ADDENDUM NUMBER 3

R17-28 Chemoy-Dogwood Watermain Install & Replacement

January 4, 2018

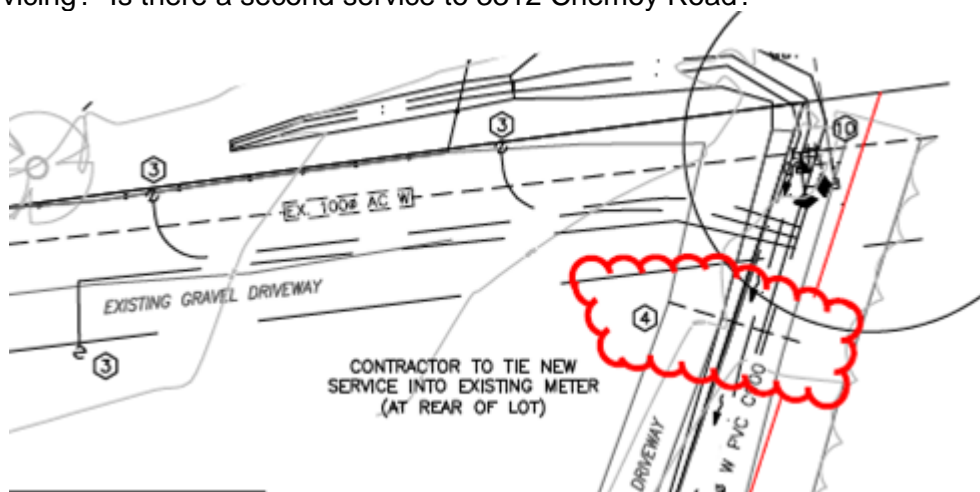
Q10. Drawing 1297-C-01 shows a service as highlighted below. Please clarify what this is servicing? Is there a second service to 3312 Chemoy Road?

A10. Delete – see amended drawing

1297-C-01

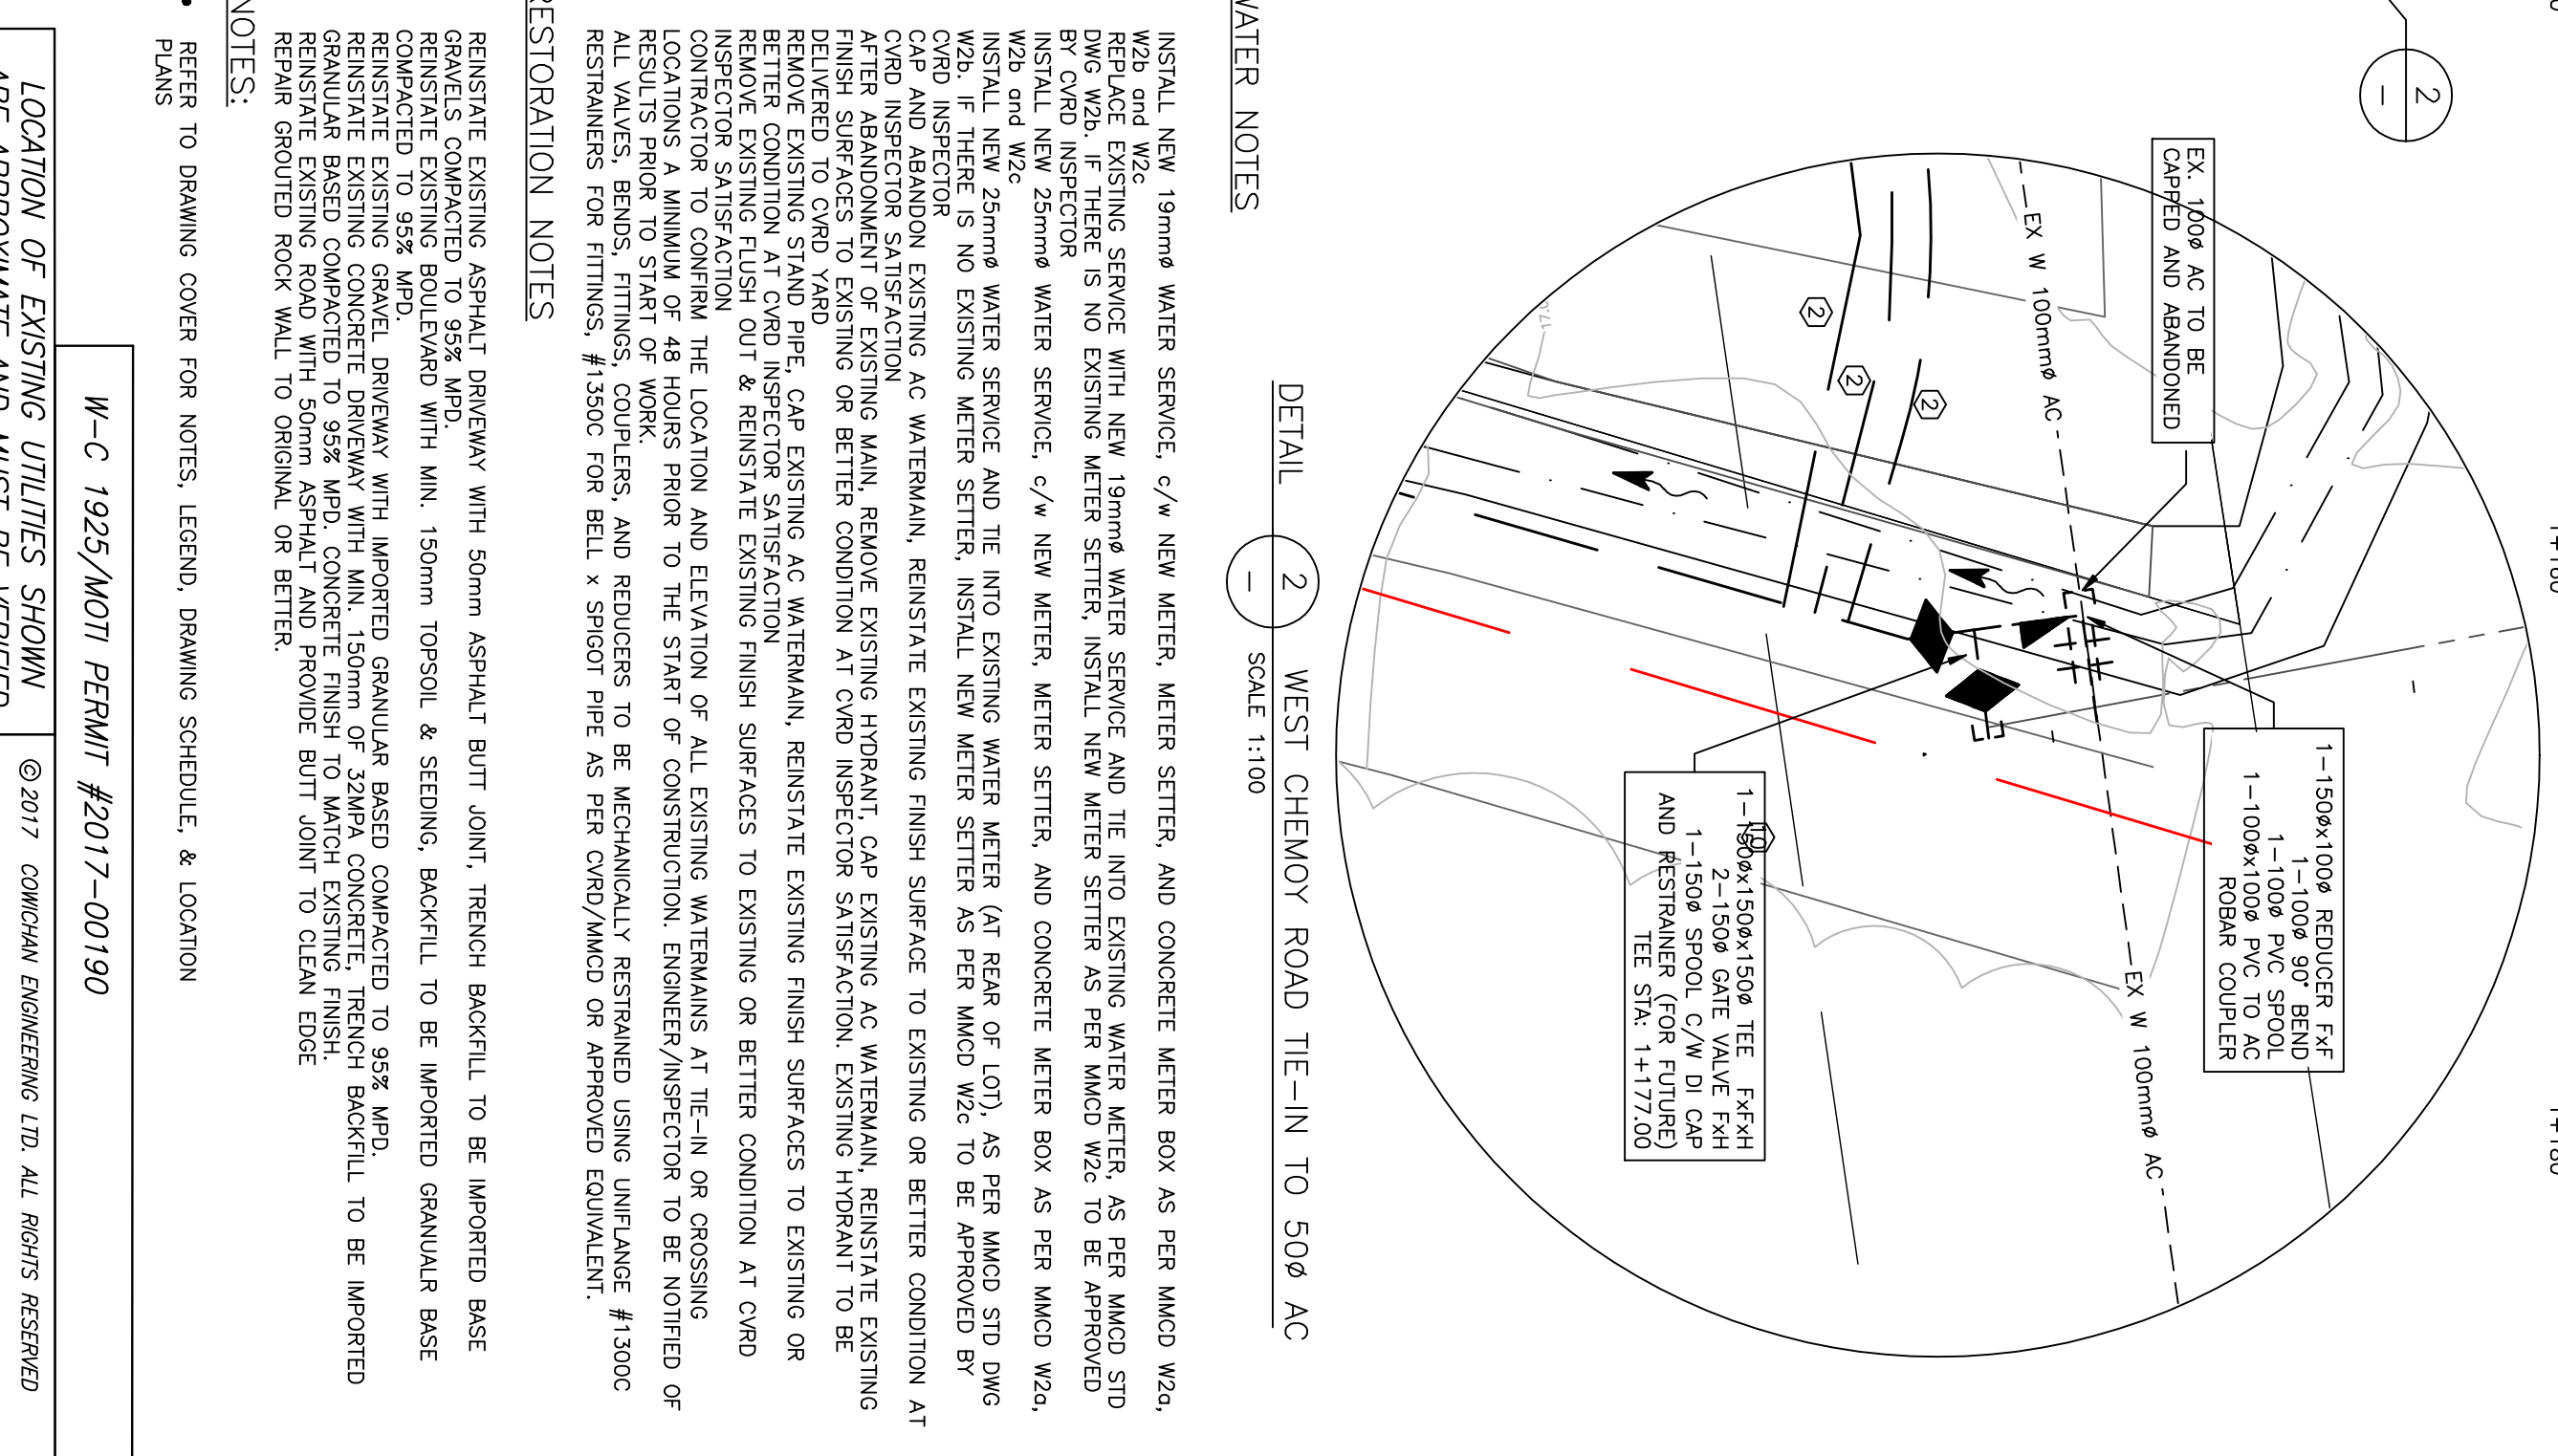
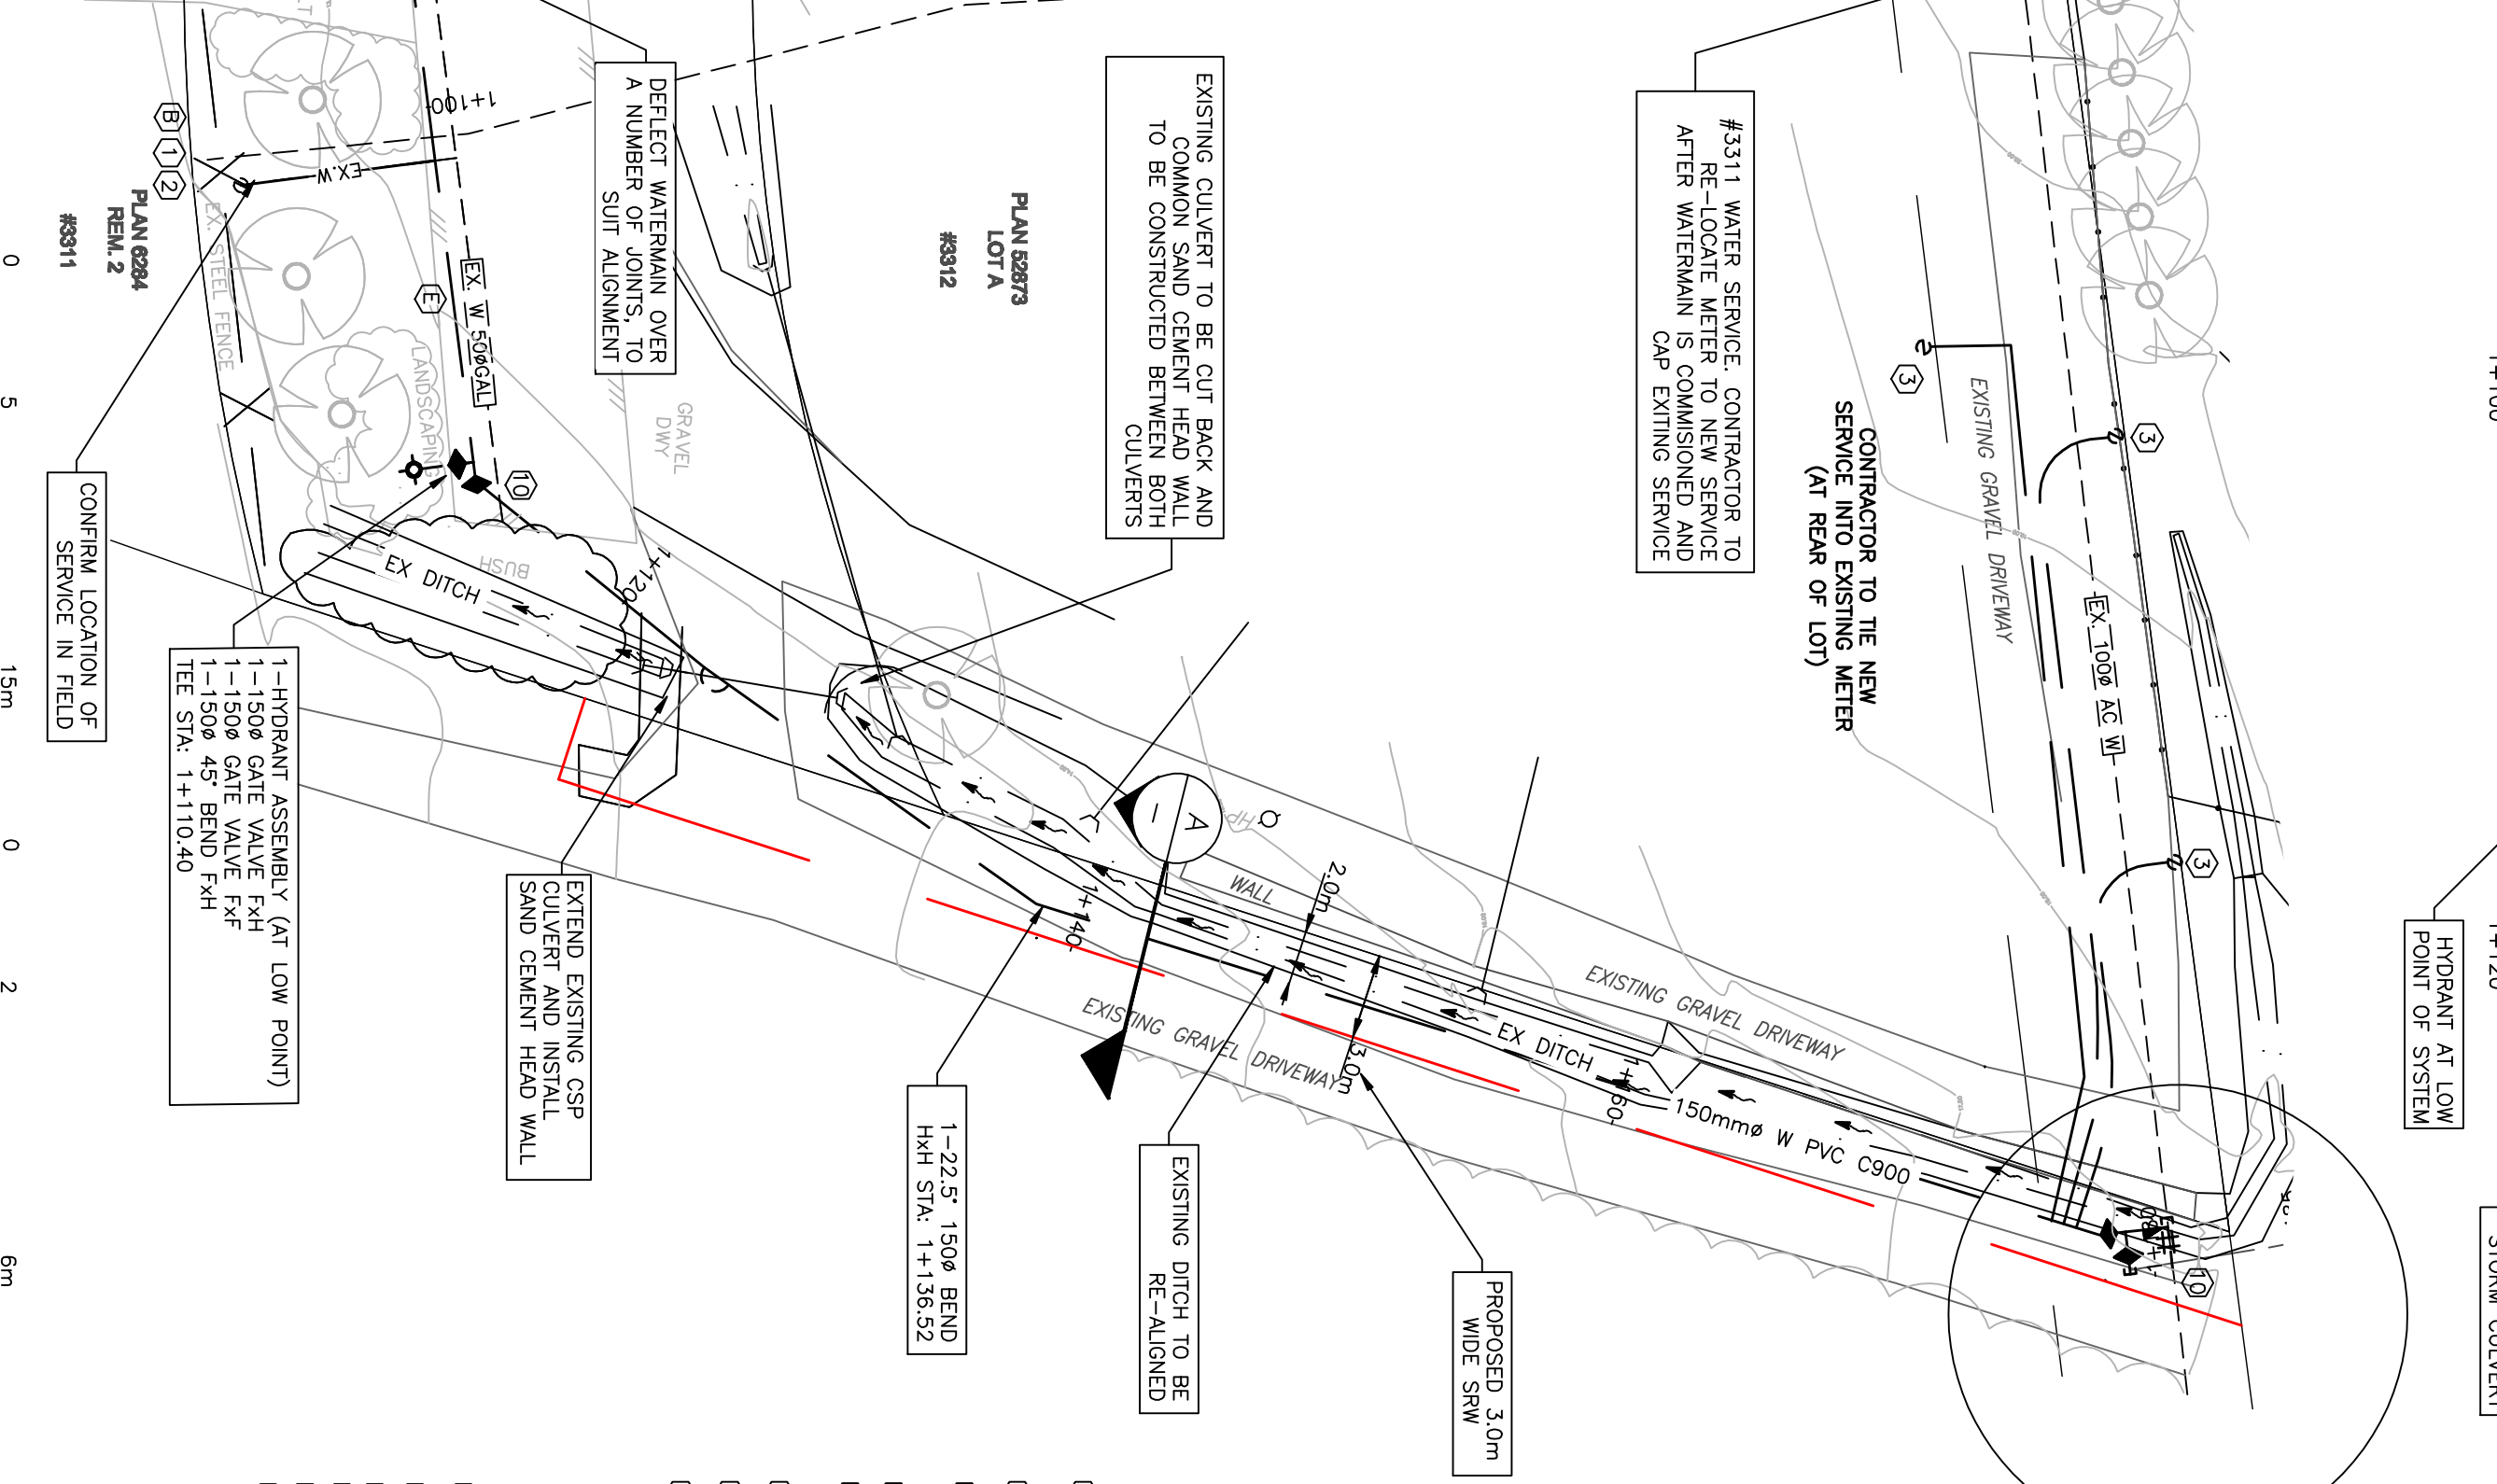
Q5. To reduce the cost of the services to #3304 and #3308 Chemoy Road, will the CVRD allow for pricing to include bringing the new service line to the front of the building only with the assumption that a plumber can reroute the water line internally bringing it to the front.

Q14. The existing watermain on Chemoy Road is shown as 50mm Galvanized Pipe, however at the tie-in location (Detail 1 on drawing 1297-C-01) it is shown as both 50mm AC and 100mm AC. Please confirm size of pipe and material.

A5. The alignment of the water service for 3304 Chemoy Road has moved to the opposite side of the property. The revised drawings shows the new alignment of the water service to the left of the driveway. All work is to be completed outside of the homes.

A14. The addendum #3 drawing will reflect the change.
